Re: Geologic Hazard Additional Borings
Springs at Waterview East (Trails at Aspen Ridge)
South Powers and Bradley Road
Colorado Springs, Colorado

A Soils, Geology and Geologic Hazard Study was prepared by Entech Engineering, Inc., Revised Date February 8, 2019, for the above referenced site. This letter is in response to the Colorado Geological Survey (CGS) review letter dated July 19, 2019, CGS Unique No. EP-18-0011_5 which is attached to this letter.

**Subject: Trails at Aspen Ridge PUDSP191 (previously reviewed as Springs East at Waterview SP-17-010)
El Paso County, CO; CGS Unique No. EP-18-0011 5**

**SITE PLAN/TEST BORING LOCATION MAP
SPRINGS AT WATERVIEW EAST
S POWERS BOULEVARD AND BRADLEY ROAD
EL PASO COUNTY, CO.
FOR: COLA, LLC**

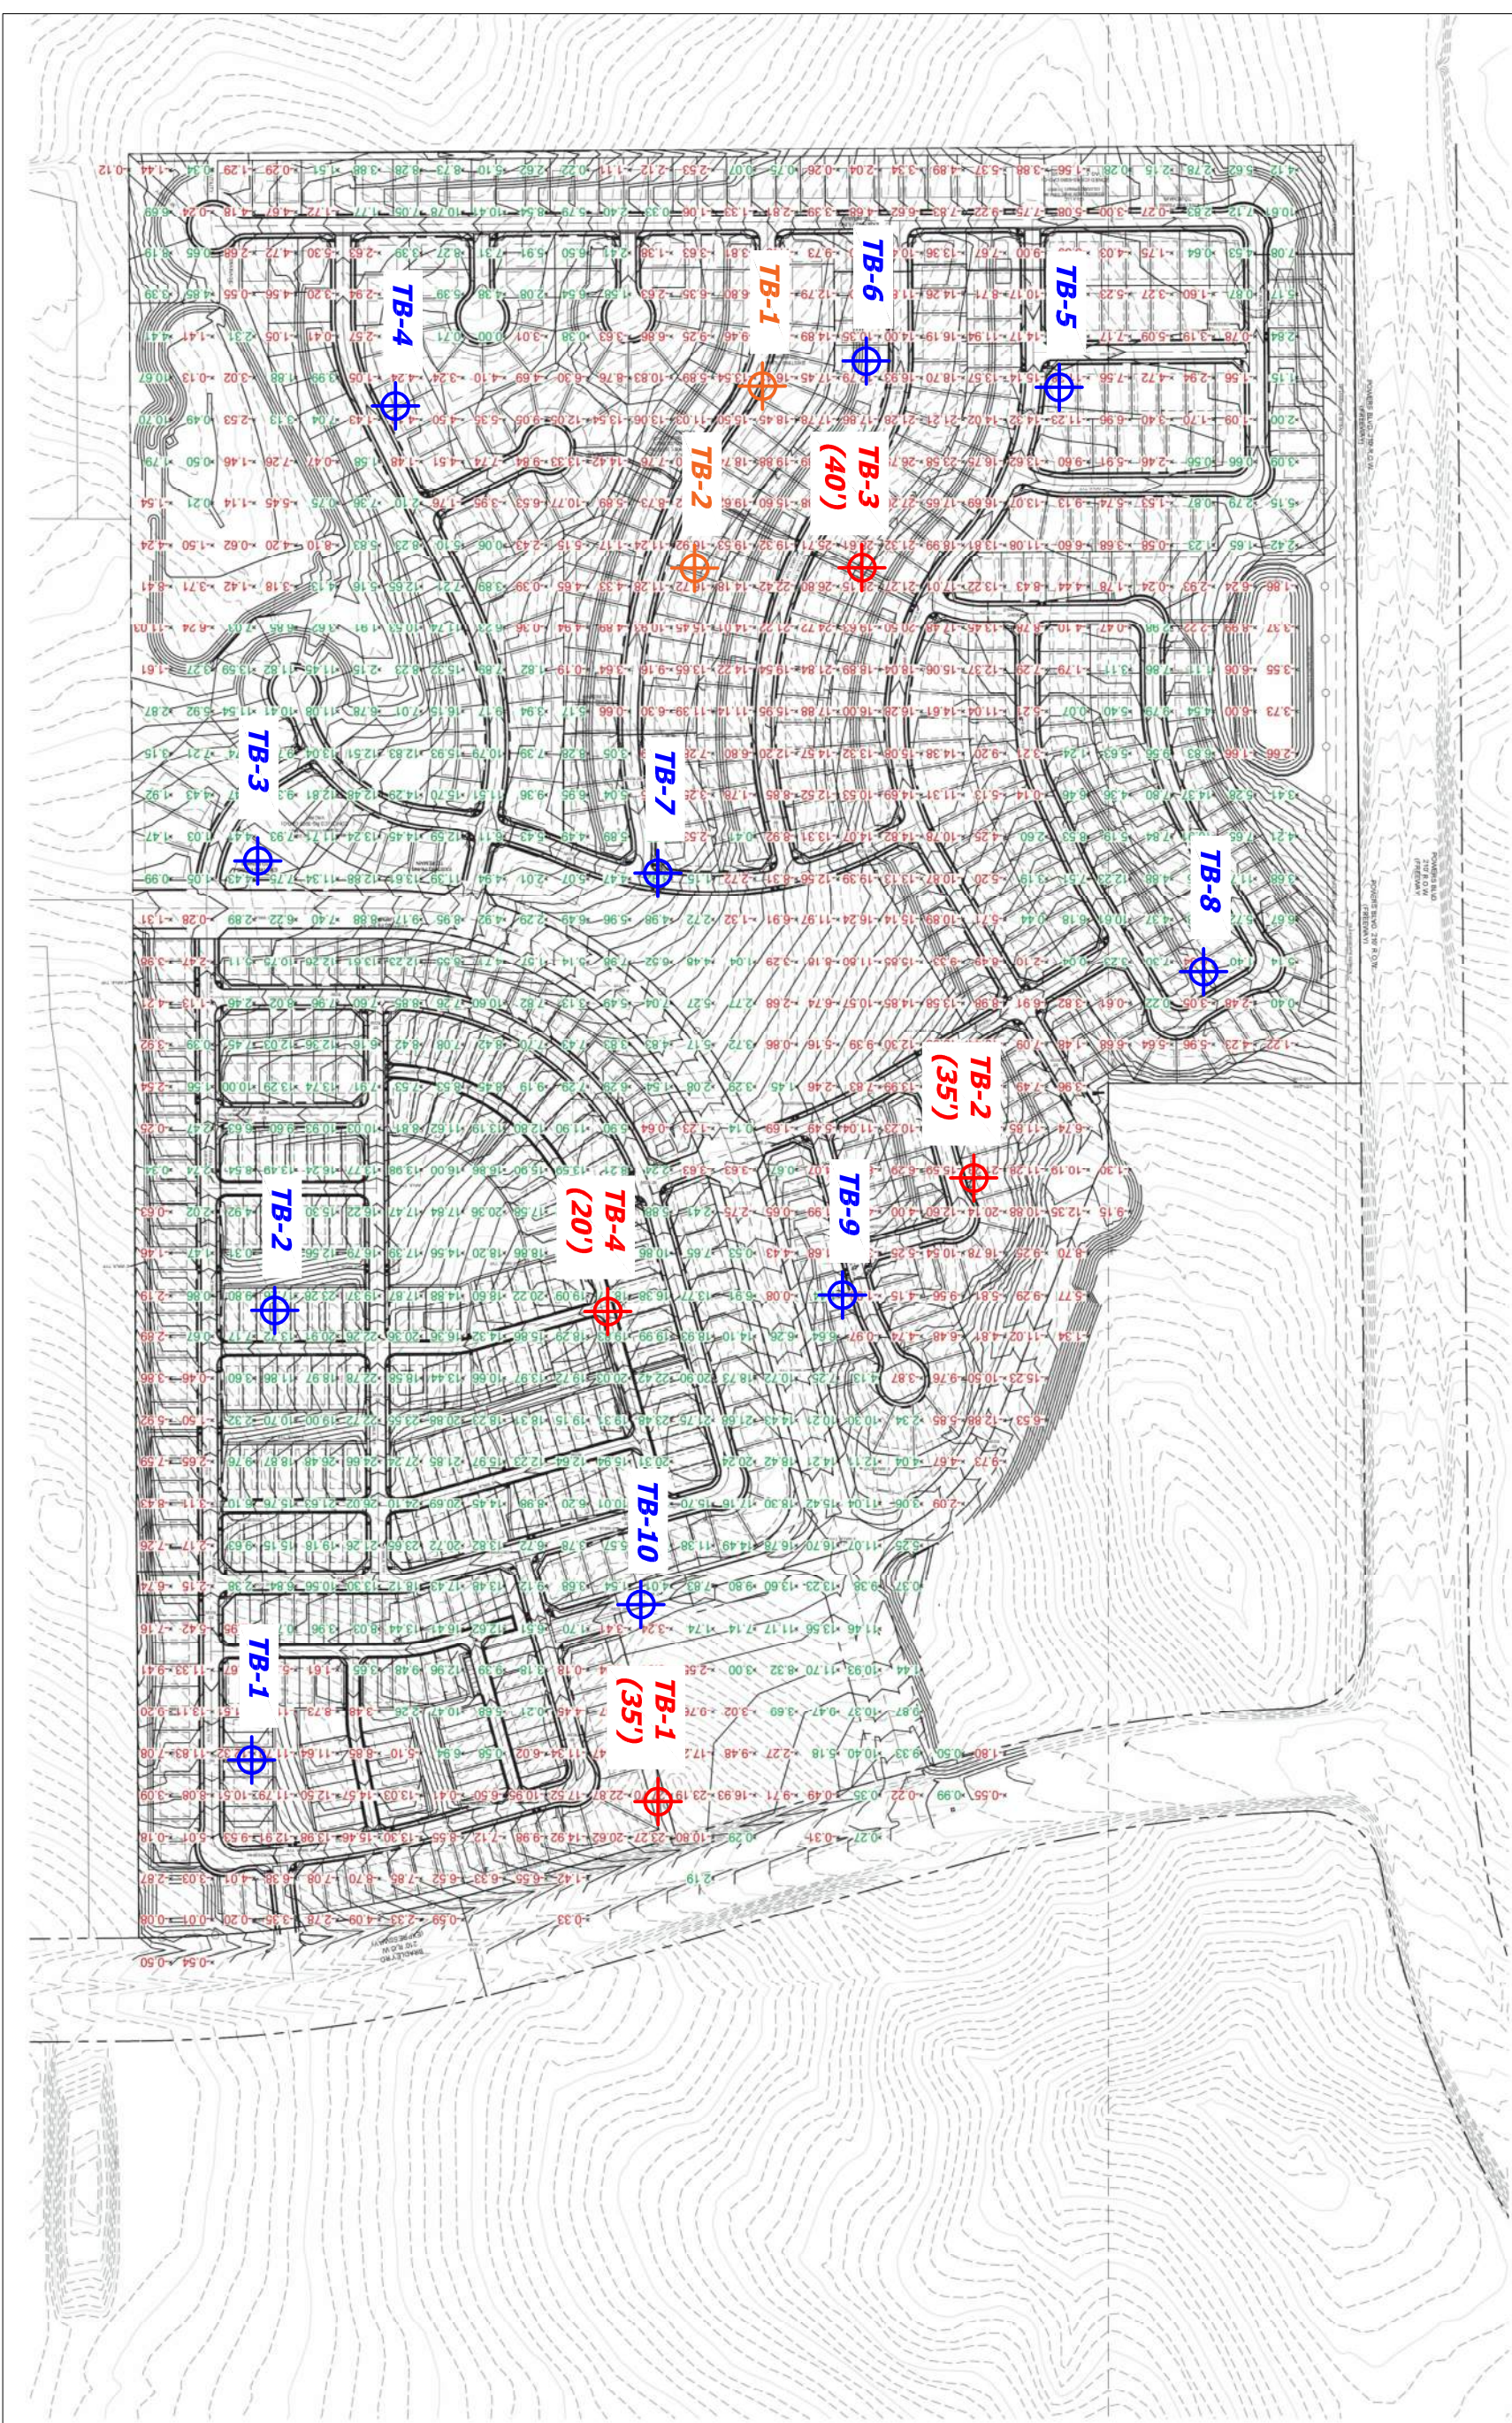
CGS recommended additional investigation on the site in areas where significant cuts are proposed. Entech drilled four additional borings on August 7, 2019. Test Boring locations are shown on Figure 1. Test Boring Nos. 1 – 3 were drilled in areas of deep cuts, and Test Boring No. 4 was placed in an area of significant fill. Groundwater was not encountered during drilling or subsequent to drilling. The test borings were drilled to depths of 20 to 40 feet. Soils encountered in these borings consisted of predominantly sandy clay soils with underlying claystone and shale bedrock. The bedrock underlying the site is the Pierre Shale Formation of Cretaceous Age, which typically has a moderate to high expansion potential.

The new borings do not alter the conclusions in the previous reports. Based on the additional subsurface information, it is anticipated claystone or shale will be exposed in the majority of cuts proposed on the site. These soils have the potential for moderate to high expansion potential. Mitigation of the expansive soils will be required for the majority of the site. Specific recommendations for foundations and construction will be provided in the Subsurface Soil Investigations after additional site investigation is performed for the different phases of the development prior to construction.

VICINITY MAP/TEST BORING LOCATION PLAN
LEGACY DRIVE - BORROW SITE
EL PASO COUNTY, CO
FOR: COLA, LLC

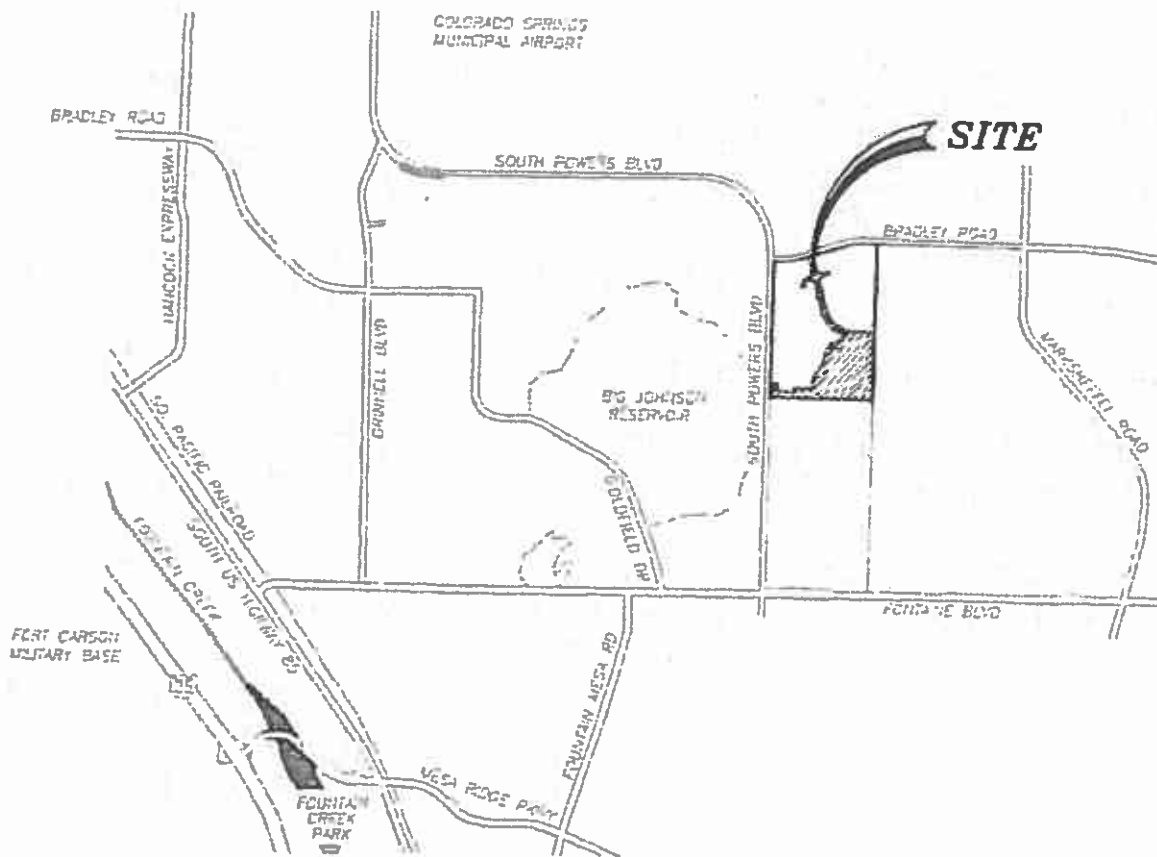
Entech's Appendix B boring TB-1 is located near the Legacy Drive/Frontside Drive cul de sac where, according to sheet 4 of the June 2019 Grading & Erosion Control Plans, approximately 10-15 feet of fill is proposed. TB-2 is located northwest of the Legacy/Frontside cul de sac, in a commercial area outside of the Trails at Aspen Ridge development area, described on sheet 4 of the grading plans as "unplatted."

TEST BORING LOCATION MAP
TRAILS AT ASPEN RIDGE-BORROW SITE
EL PASO COUNTY, CO
FOR: COLA, LLC

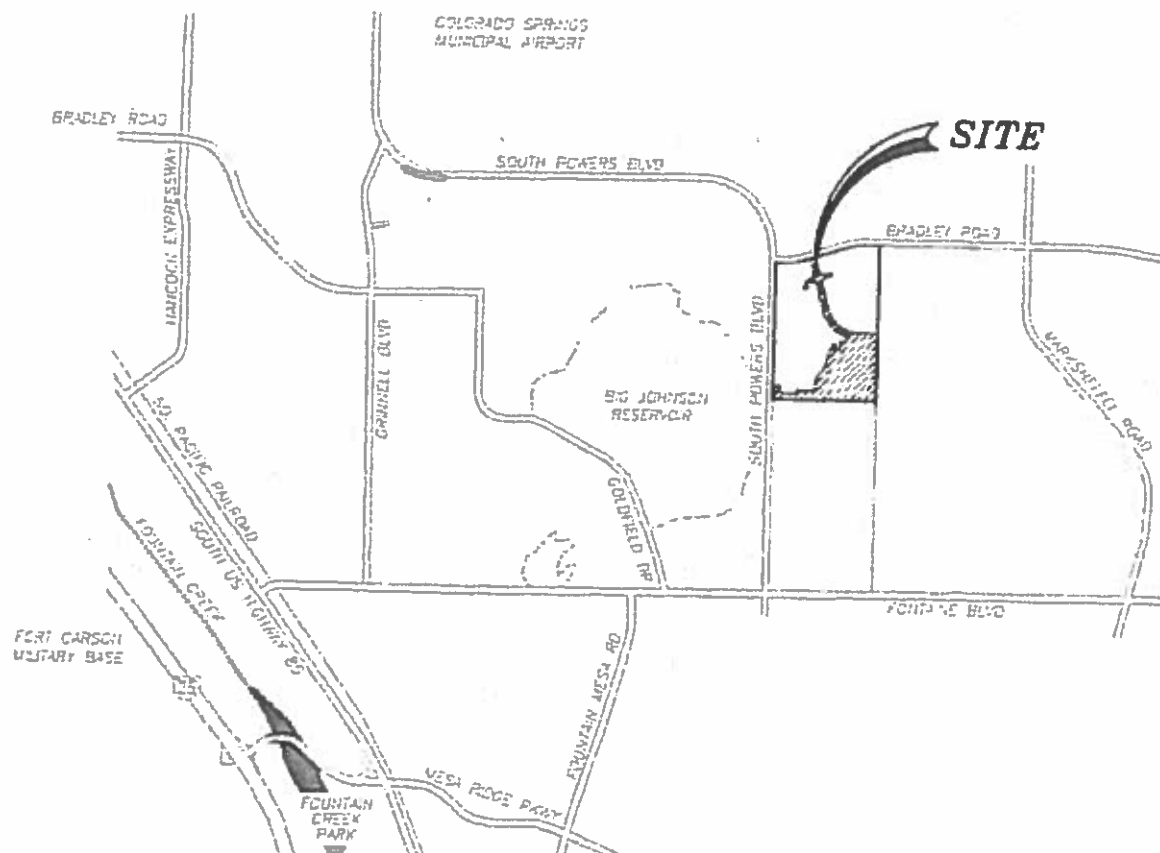
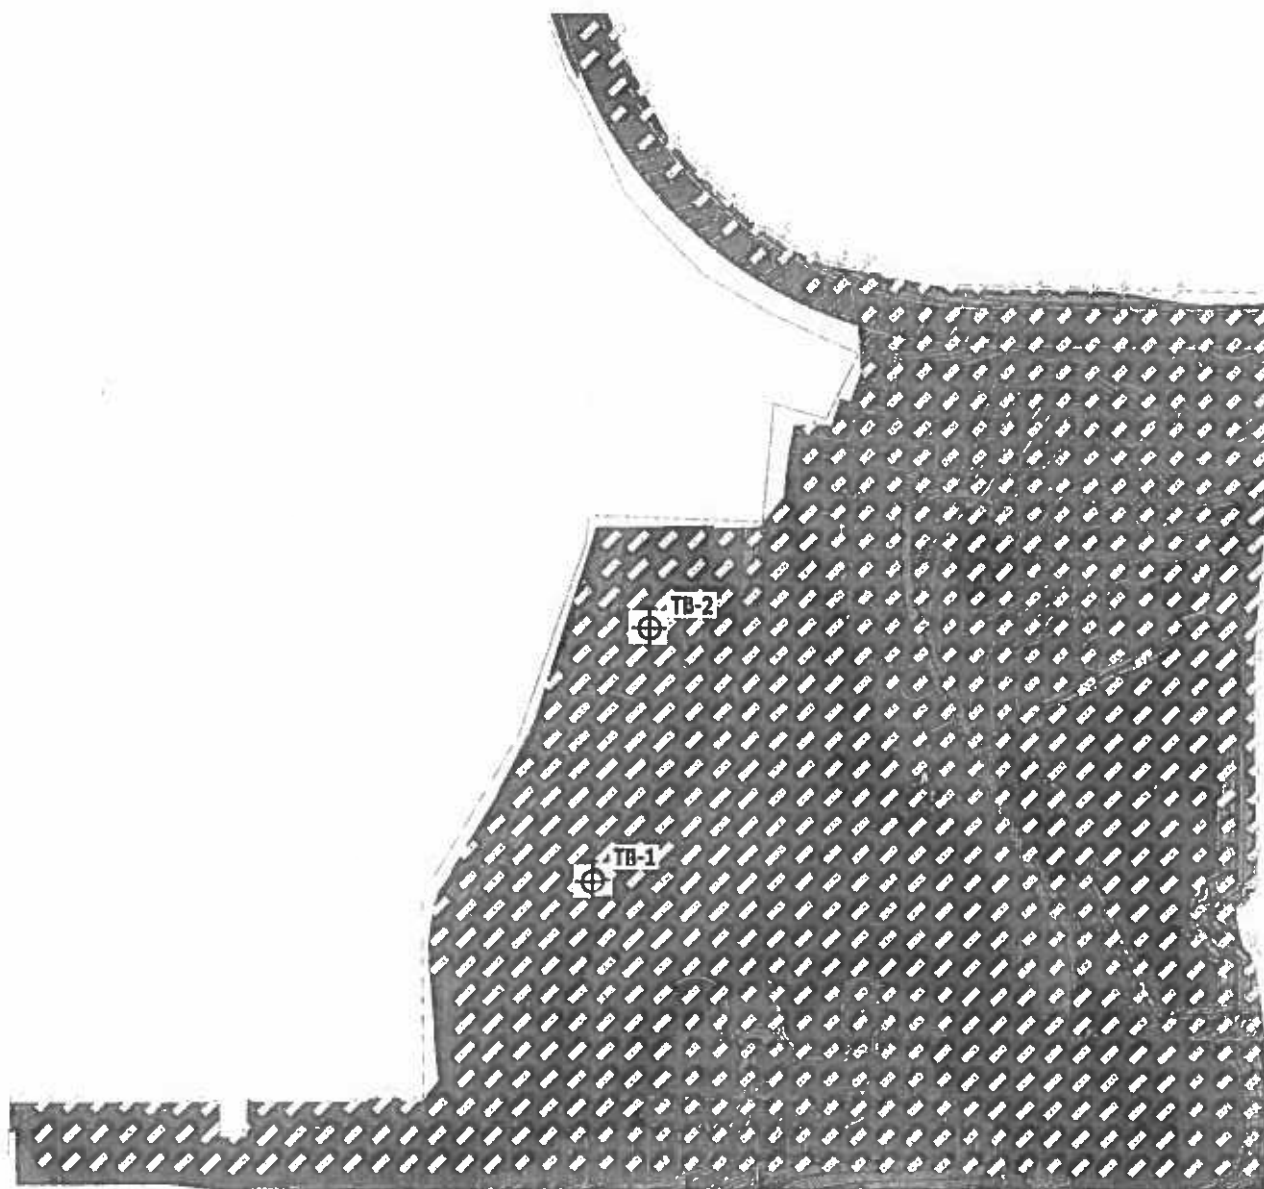
The locations of Entech's Appendix C borings are difficult to determine because of the poor quality of Figure 2, but appear to be located east of proposed Wagon Hammer Drive, outside of the currently proposed Trails at Aspen Ridge development area, within the existing Phase I (Not a Part)/Filing I Area To Remain identified on the PUD and grading plans.
